# MONITORING YEAR 5 ANNUAL REPORT

## CANDY CREEK MITIGATION SITE

RE: **Draft Monitoring Year 5 Report Comments  
Candy Creek Mitigation Site (DMS #96315)**  
Cape Fear River Basin 03030002, Guilford County  
Contract No. 005794

Figure 3.4 Integrated Current Condition Plan View  
Candy Creek Mitigation Site  
DMS Project No. 96315  
Monitoring Year 5 - 2021  
Guilford County, NC

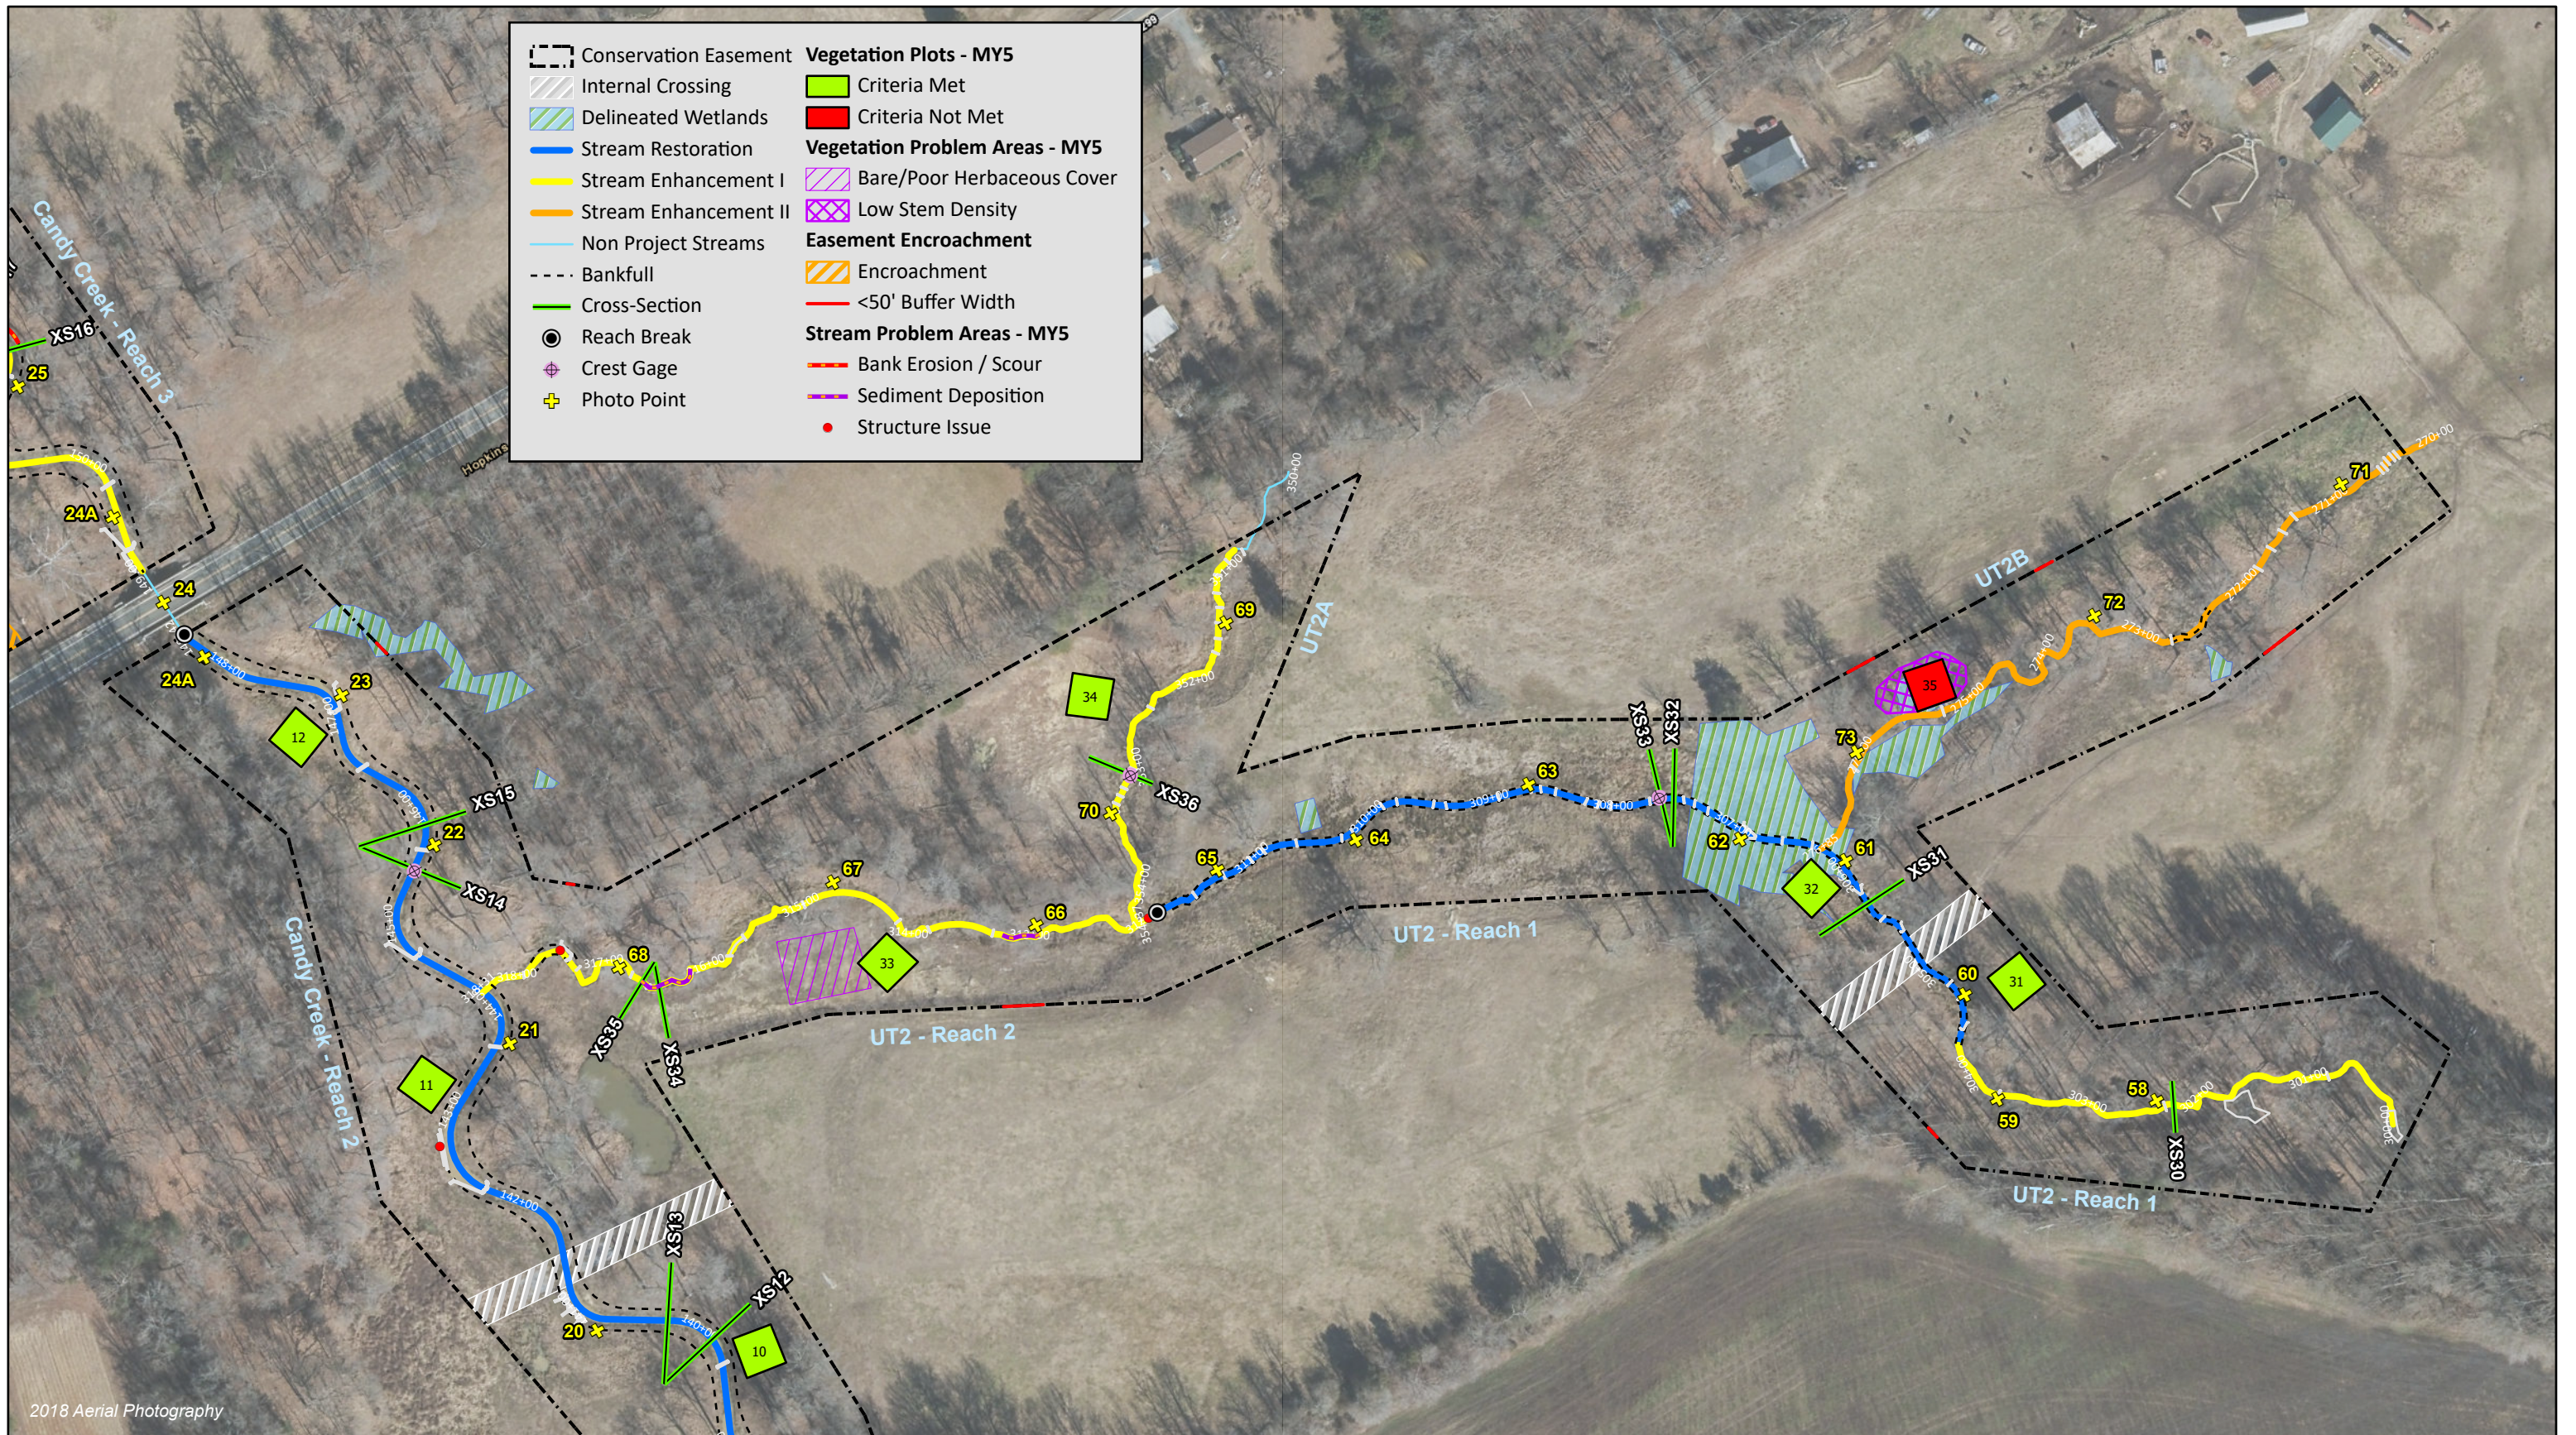
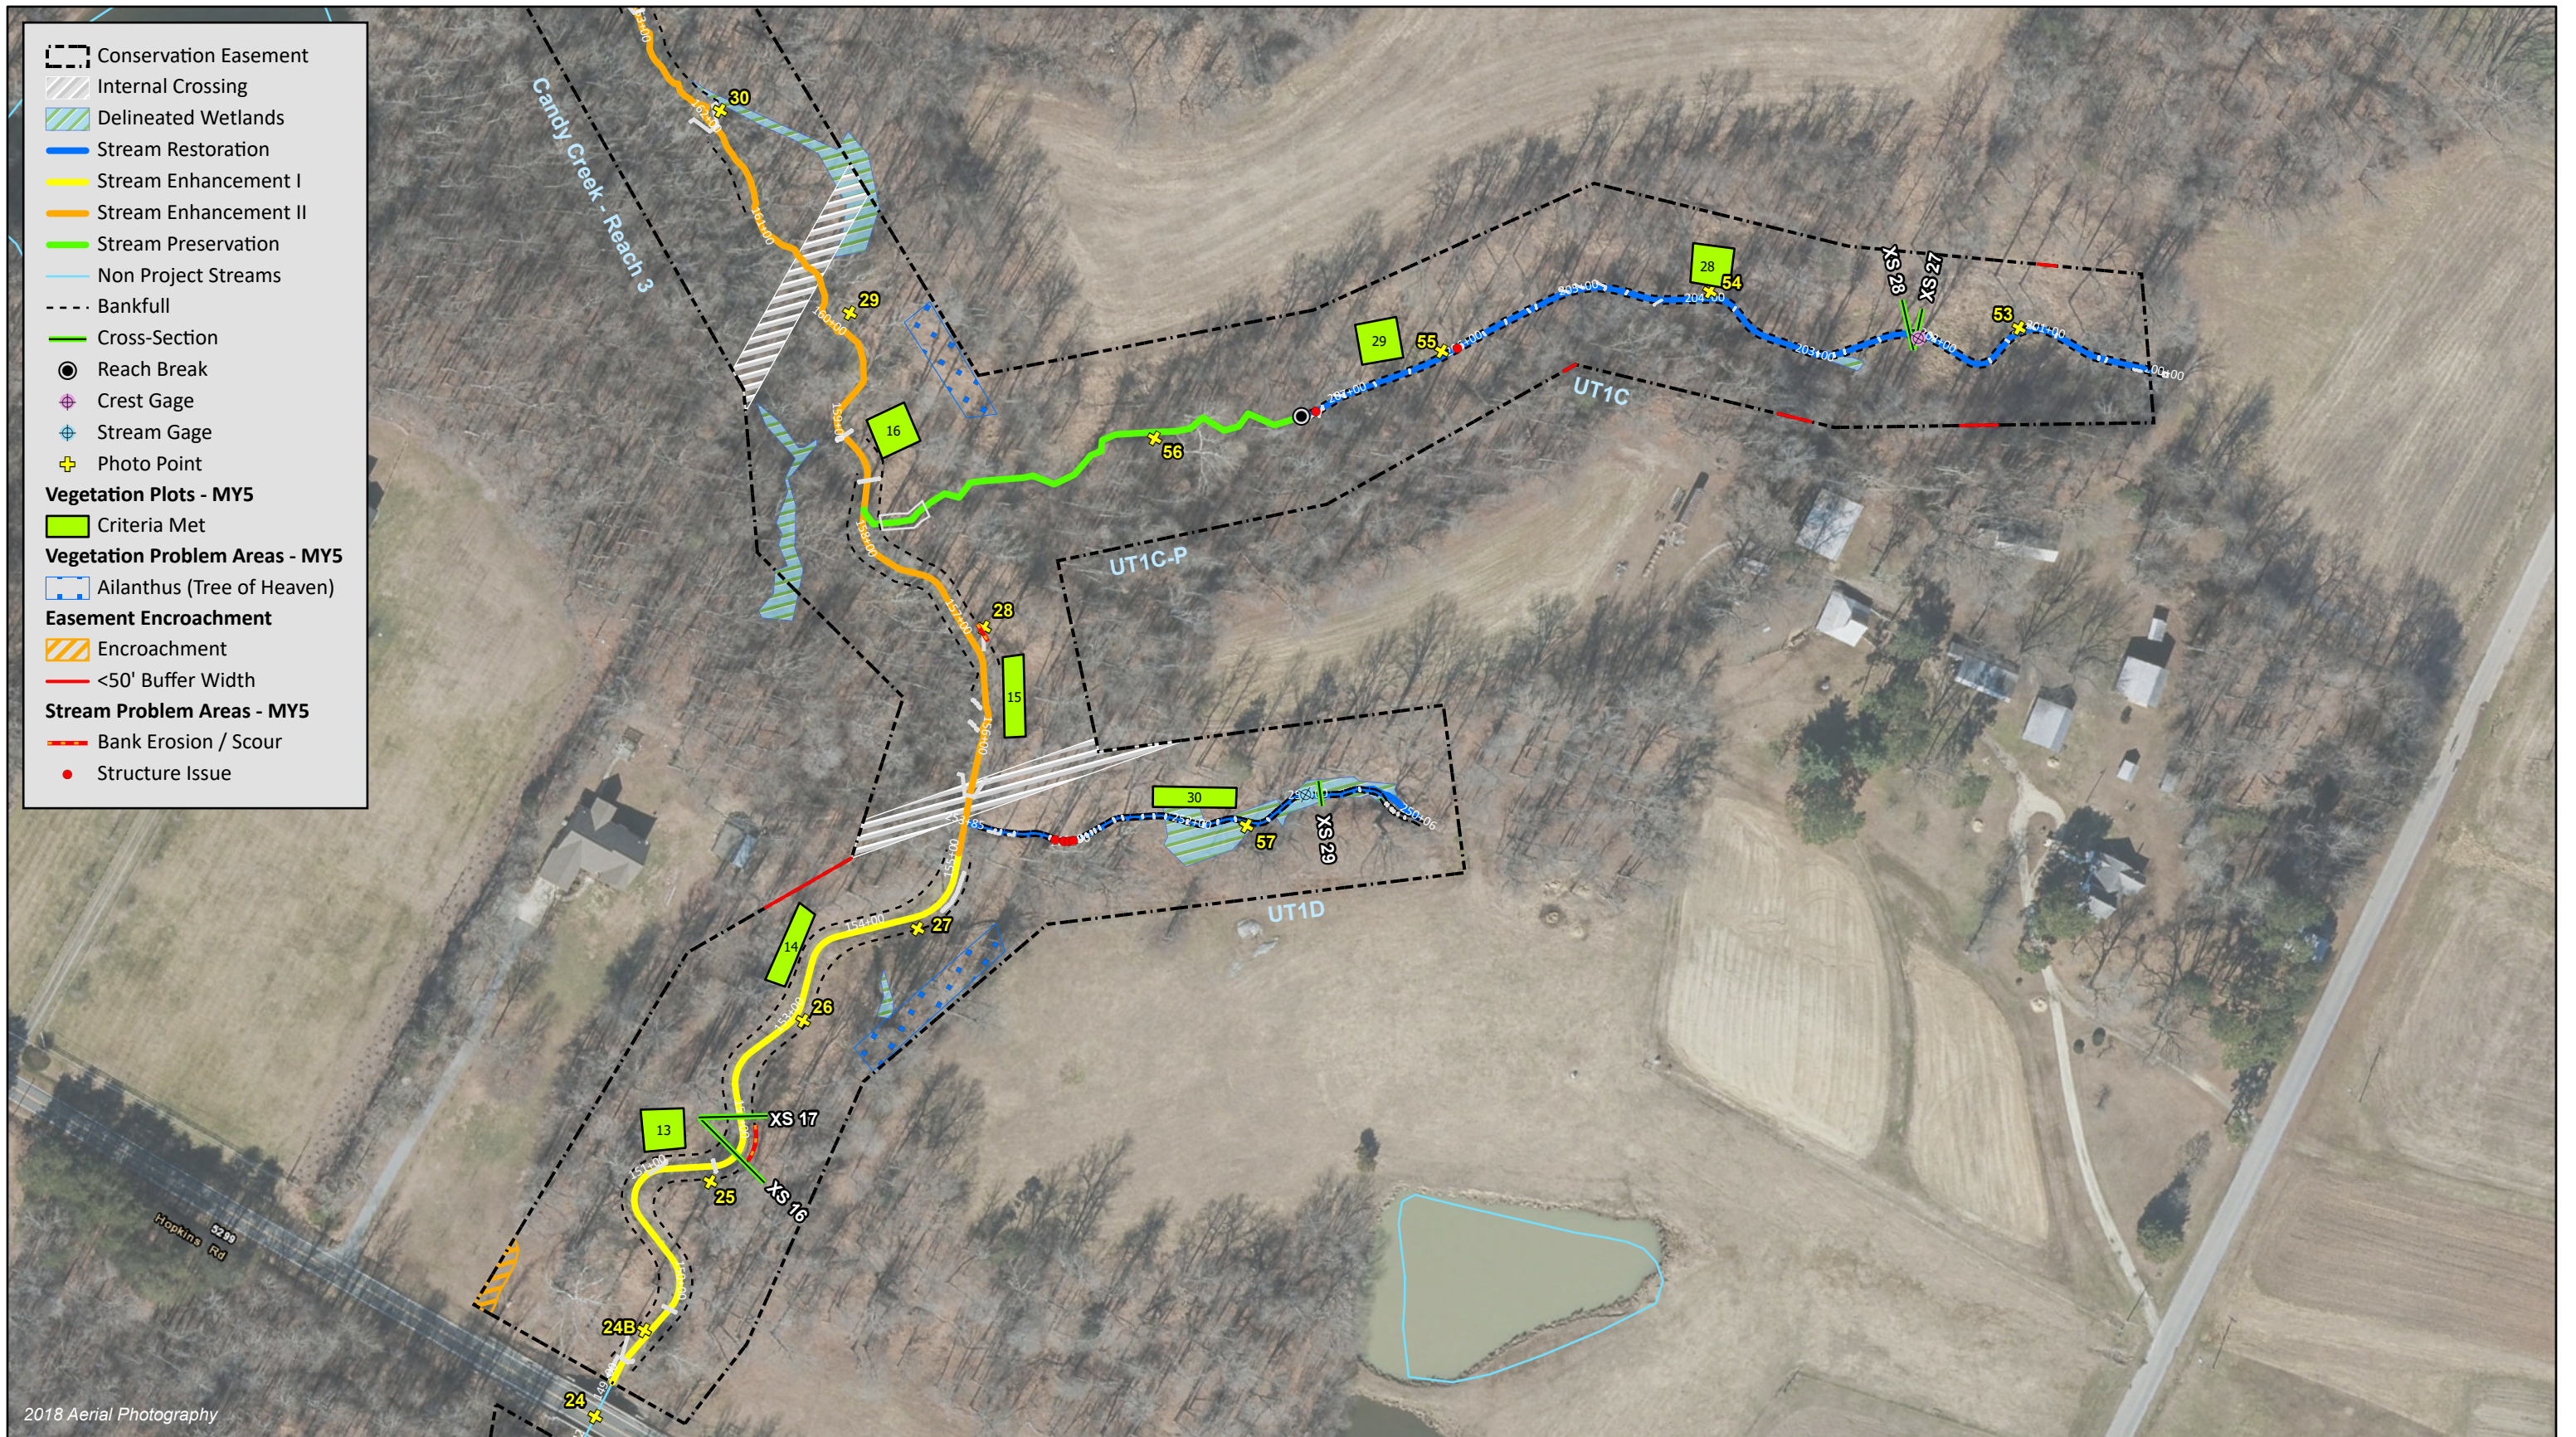
- a. **Please ensure that the stream areas of concern values reported in Table 5 reflect the submitted spatial data. For example, there are 2 aggradation features submitted for UT5 with a combined length of 130 ft, whereas Table 5m reports 3 segments with a length of 110 ft.**

*Wildlands' response: The submitted geodatabase, the associated figures (Figures 3.0-3.7), and the associated assessment tables (Tables 5a-5m) were checked and corrected so that the feature counts now match. For example, Table 5m now reports 2 segments of aggradation totaling 130ft, as shown in Figure 3.1; and the one structural issue for Overall Integrity on Candy Creek Reach 4 is now drawn on Figure 3.7. Where bed or structure issues overlap with an existing issue, notes were added to the attribute tables rather than adding additional features to the maps. For example, one of the aggradation issues mapped on UT4 and shown in Figure 3.2 and Table 5l, corresponds to two riffle condition-substrate and 1 pool condition-depth issues, which is now indicated in the attribute table.*
